**CMD: 21-H109**

Issue requiring approval for a change  
in licensing basis

**Canadian Light Source  
Incorporated**

Submitted by:  
CNSC Staff

Figure 4- ESL lab (0006 and 0006.1) outlined in black with planned area modifications indicated in red. Other planned modifications shown will be completed at later stages of the project. Source: CLSI submission with CNSC staff markup.

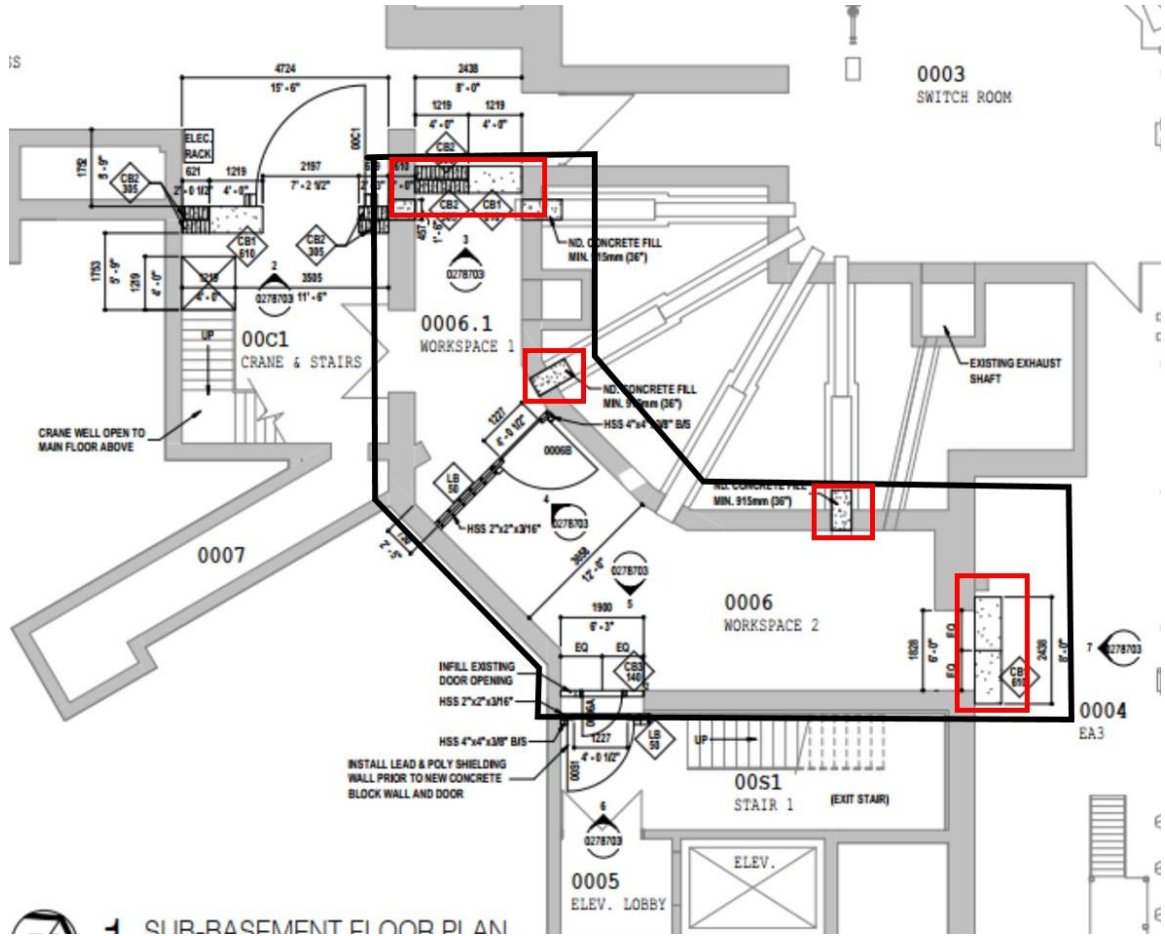
A 2018 [failure of CLS's electron source](#) (an integral component of the 250 MeV electron linear accelerator) resulted in an extended outage. CLSI has identified the need for a location within the facility to test and develop electron sources so that electron source failures do not result in extended outages. The proposed ESL area is located in the subbasement of the CLS facility, in rooms 0006 and 0006.1, as shown in Figure 4.

CLSI's application included a description and plans for additional shielding to be installed in order to reduce dose rates to levels that permit occupancy according to CLSI's current procedures (<1 mSv/h). CNSC staff have performed independent calculations for the ESL area with the proposed additional shielding in place, and they are in-line with CLSI's estimates of the dose rates when the synchrotron is operating. CNSC staff find CLSI's proposed dose rate survey plan prior to permitting occupancy while the synchrotron is operational to be acceptable. It includes dose rate measurements under various worst-case electron beam conditions at different points in the ESL. The maximum synchrotron current and electron energy used during the dose rate surveys submitted to the CNSC (see Table 1) will become the administrative operating limit of the CLS. CLSI must perform new surveys if they want to operate the synchrotron at parameters higher than those used on the initial survey.

CLSI must modify the ACIS in order to permit occupancy of the space. The ESL area will be removed from ACIS control. CLSI will merge the small section of space adjacent to the ESL that remains under ACIS protection with an existing ACIS zone. CLSI's ACIS design manuals and safety system development strategy listed in the LCH adequately describe the design and verification and validation of ACIS. CNSC staff have assessed the proposed ACIS design change, and confirm that it is acceptable. CLSI is required to submit the results of surveys, and
